Staff Report

To: Development Review Board
From: Michael Giguere, City Planner
Meeting Date: March 20th, 2025
Subject: Site plan amendment for three (3) additional dwelling units and opening of the fifth floor at existing multi-family building at 197 Pearl Street by Jiddu/Sittu Trust c/o Gabe Handy.
File: SP#5.2016.6

Re: Proposed Revisions to Permit - 197 Pearl Street
Development Application Cover Letter

Unit 413 Floor Plans

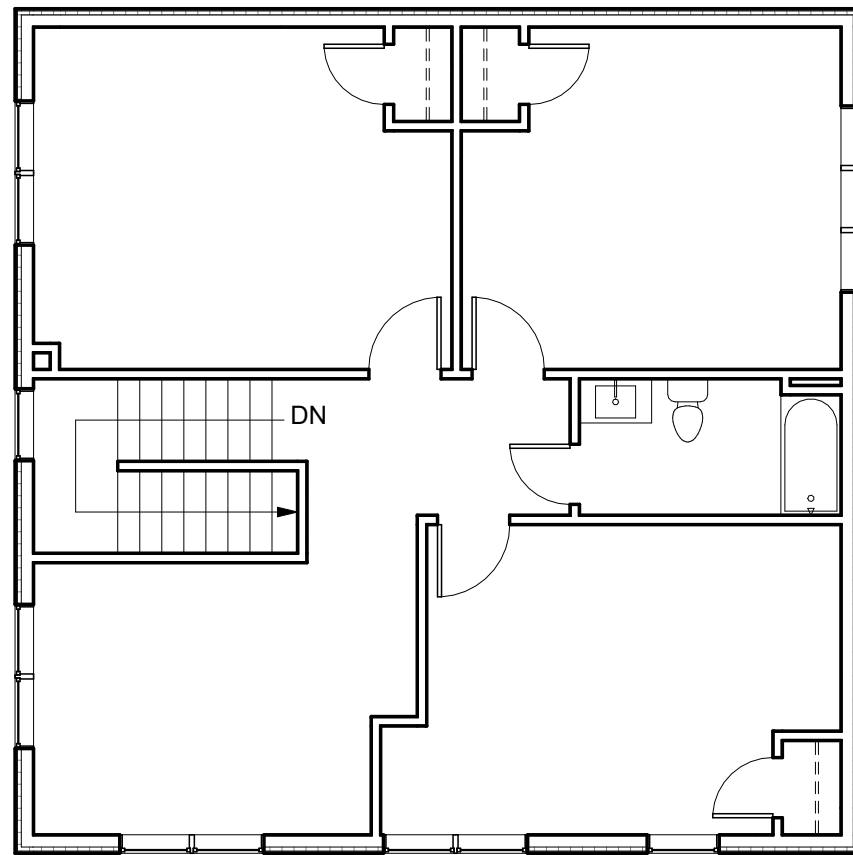
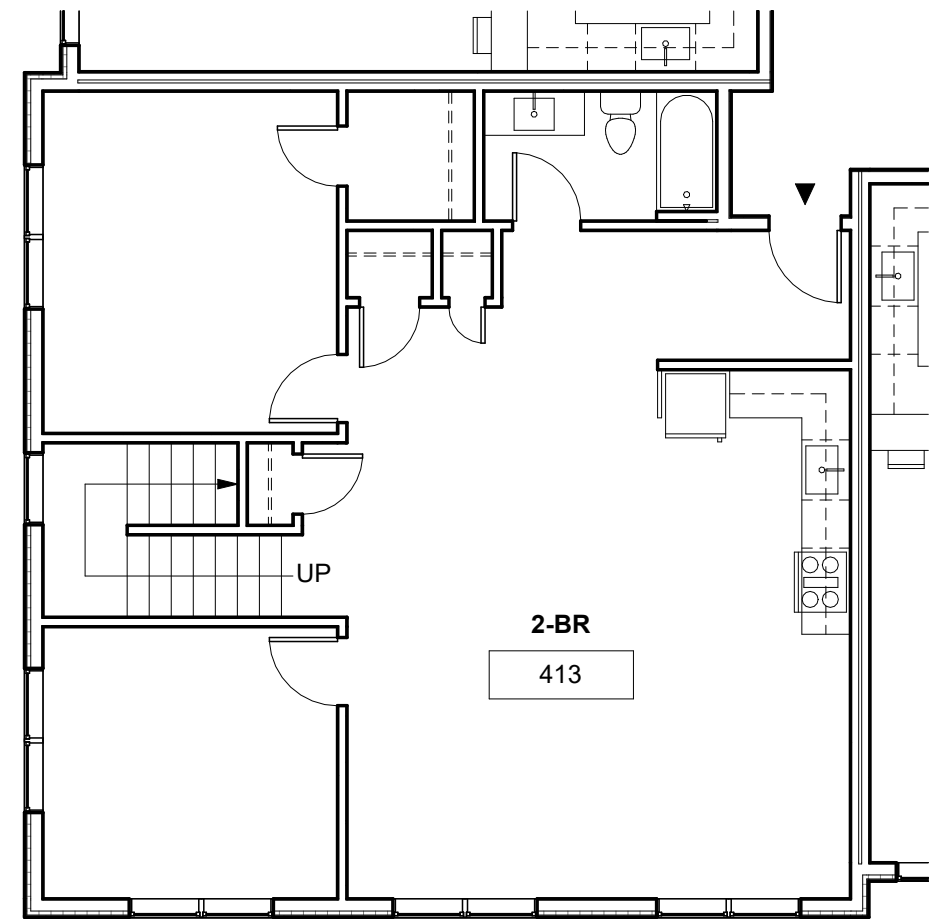
For the original site plan approval in 2017, the Planning Commission approved this project for four stories, which was the limit in the MF-MU1 district at the time. During construction, an additional floor was built, turning Unit 413 from a two-bedroom unit located entirely on the fourth floor into a penthouse unit with floor area on the fourth and fifth floors. The building remained within the total height limit of 58 feet above grade.

Upon the discovery of this discrepancy, City staff required the property owner to seal off the fifth floor to comply with LDC requirements. City staff verified that this floor was sealed off and not occupiable prior to issuing a Certificate of Occupancy for the building in September 2023.

The constructed building is five (5) stories 53 feet tall, which meets district requirements. Staff have added Essex Junction's affordable housing reporting requirements as conditions of approval.
